MB9AA30N/130N/B40NA/A40NA/340NA /140NA/150R Series

November 29, 2013

Silicon Errata for the MB9AA30N/130N/B40NA/A40NA/340NA/140NA/150R Series 32-bit ARM® Cortex®-M3 based Microcontroller

Figure 1. Arbitration Lost Detection Period (Current)

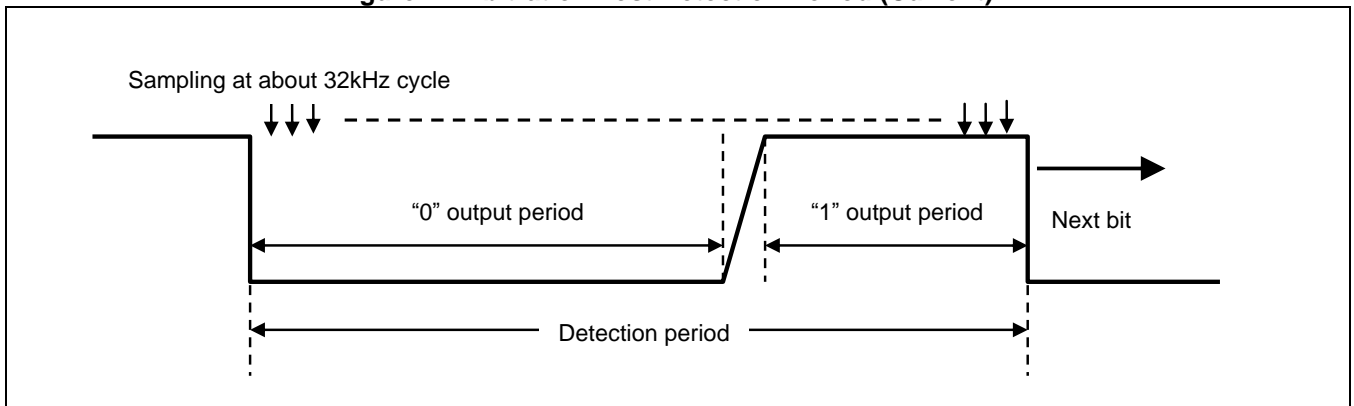
The period of arbitration lost detection is as follows:
From the start of the "0" output until the end of the "1" output period.

Figure 2. Arbitration Lost Detection Period (Modified)

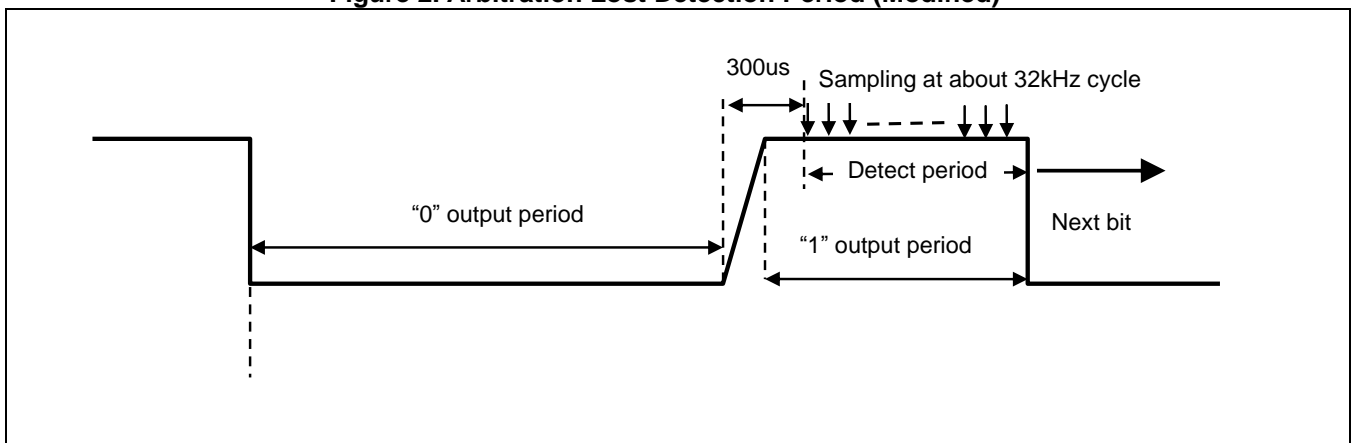
The period of arbitration lost detection is changed as follows:
During the "1" out put from 300 μ s(10 clock) after the bus data rises to high
